NUCLEAR FUEL SERVICES, INC.

Pursuant to Paragraph 50.59 of Title 10 Code of Federal Regulations, Nuclear Fuel Services, Inc. hereby requests a change in Technical Specifications for Operating License CSF-1. The proposed changes will permit the NFS Processing Plant at West Valley, New York to transfer to process and process plutonium nitrate-uranyl nitrate solutions such as now being prepared at the NFS facility at Erwin, Tennessee. The Division of Material Licensing previously approved receipt and storage of such material by Change No. 14 of the Technical Specifications of License CSF-1. The safety evaluation of the proposed processing plan and the proposed changes to the Technical Specifications are attached.

SAFETY EVALUATION
TRANSFER AND PROCESSING OF PLUTONIUM
NITRATE-URANYL NITRATE SOLUTIONS

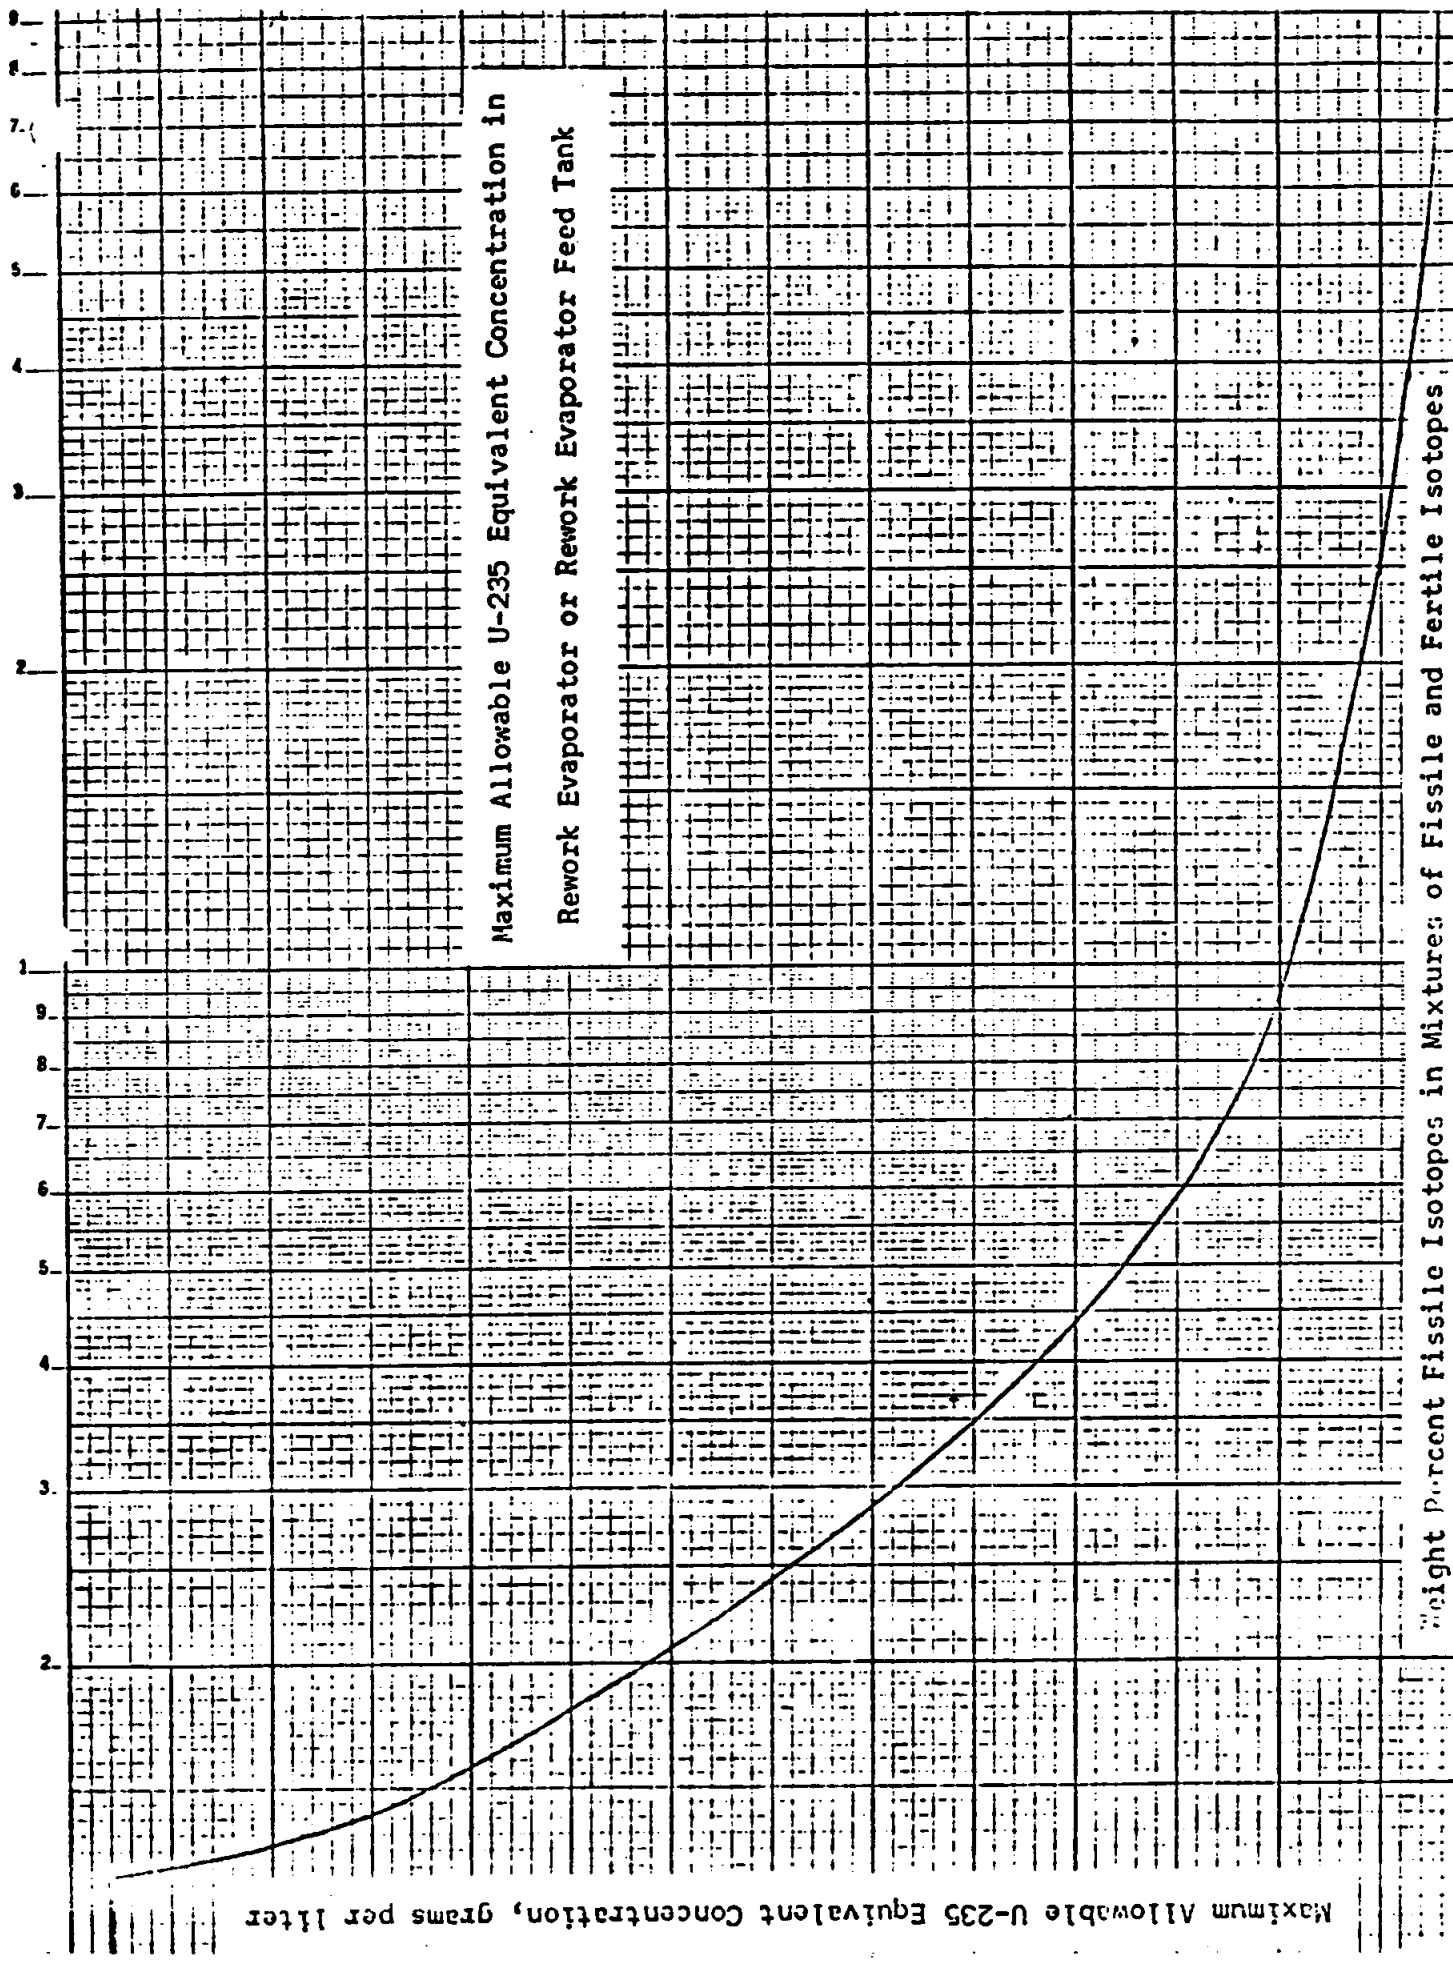
4.11.1 THE CONCENTRATION OF FISSIONABLE ISOTOPES IN THE REWORK EVAPORATOR AND THE REWORK EVAPORATOR FEED TANK SHALL NOT EXCEED THE U-235 EQUIVALENT CONCENTRATIONS SHOWN IN THE ACCOMPANYING CURVE.

Specification 4.11.1 was modified to control and authorize the processing of Category 10 fuel in the Rework Evaporator and Rework Evaporator Feed Tank. The concentration of Category 10 fuel shall not exceed the concentration shown in new Figure 4.11.1. Nuclear criticality safety is provided by controlling the fissile isotope concentration. The maximum concentrations specified in Figure 4.11.1 are, as requested by NFS, 50% of the calculated critical concentration reported in ORNL-TM-686 Limiting Critical Concentrations of Aqueous Nitrate Solutions of Fissile and Fertile Isotopes. The new concentration limits cover both U-235 and plutonium and are more conservative i.e., lower, than in the earlier specification.
